Thor Motor Coach Recall Repair Instructions

| Recall # | 23v-113 & 2023-087 | | |
| Description/Title: | Palazzo lower front cap brackets | | |
| Affected Product Line(s): | Certain model year 2015 – 2023 Palazzo motorhomes | | |

0518215 - SUPPORT, CAP, ASSEMBLY, TFM7781, ADJUSTABLE 14" - 22 1/2"

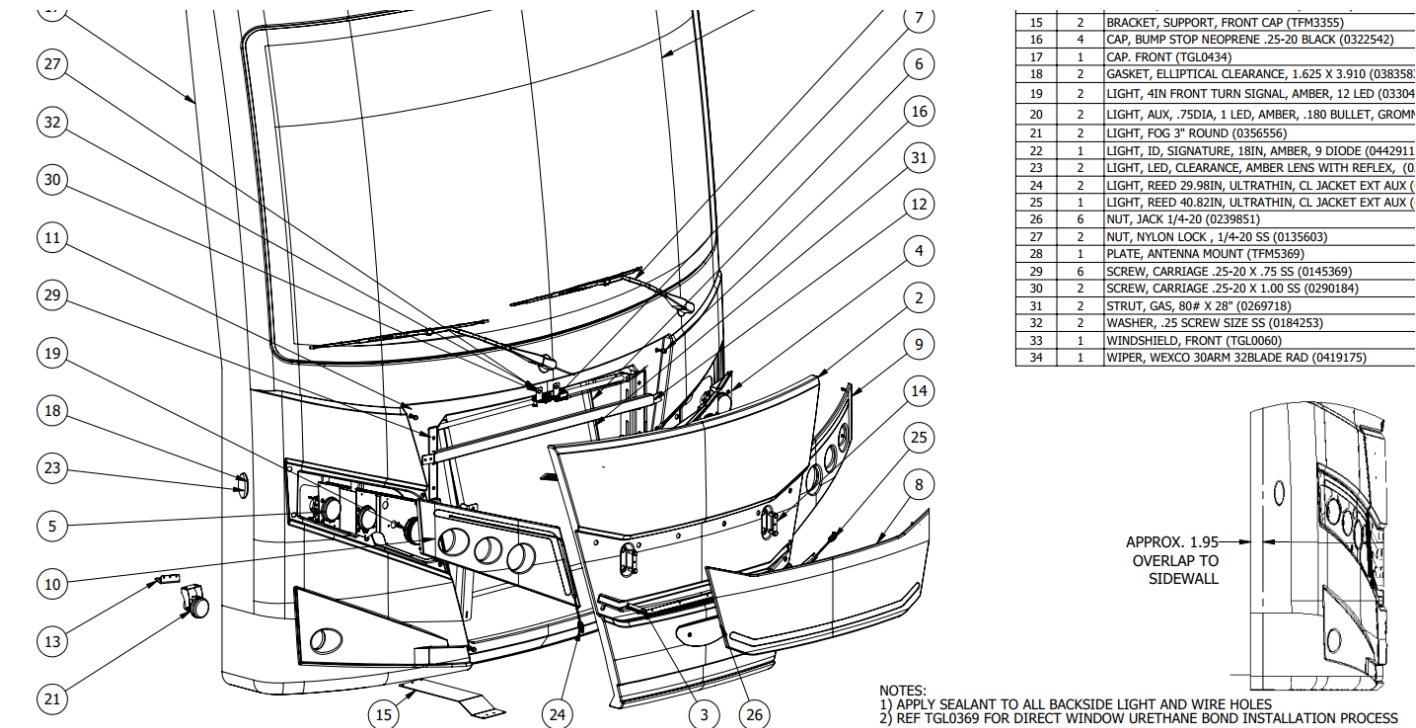
It has been discovered that on certain model year 2015 – 2023 Palazzo motorhomes that the lower front cap brackets may become loose and have the potential to fall off.

1. Inspect under the front of the motorhome to determine if one or both of the lower cap brackets are loose and/or missing. Reference print below for the location of the bracket. Bracket is identified by the ¹⁵ found on the print.

2. If the brackets are both still connected to the motorhome, ensure that the hardware used for installation matches the fasteners listed above under parts. Change out fasteners with proper hardware listed above if needed. Once that has been completed the recall has been finished, **only** continue on to step 3 if there was one or both brackets missing from the motorhome.

4. The new bracket does not match the old style bracket that may be on the motorhome. This new bracket is a slide in tube style bracket and serves the same function as the original bracket.

5. Install the new style bracket by screwing the 3/8" lag into the firewall and extending the bracket to where it needs to be installed on the underside of the cap using the #10 x 1" panhead wood screw.
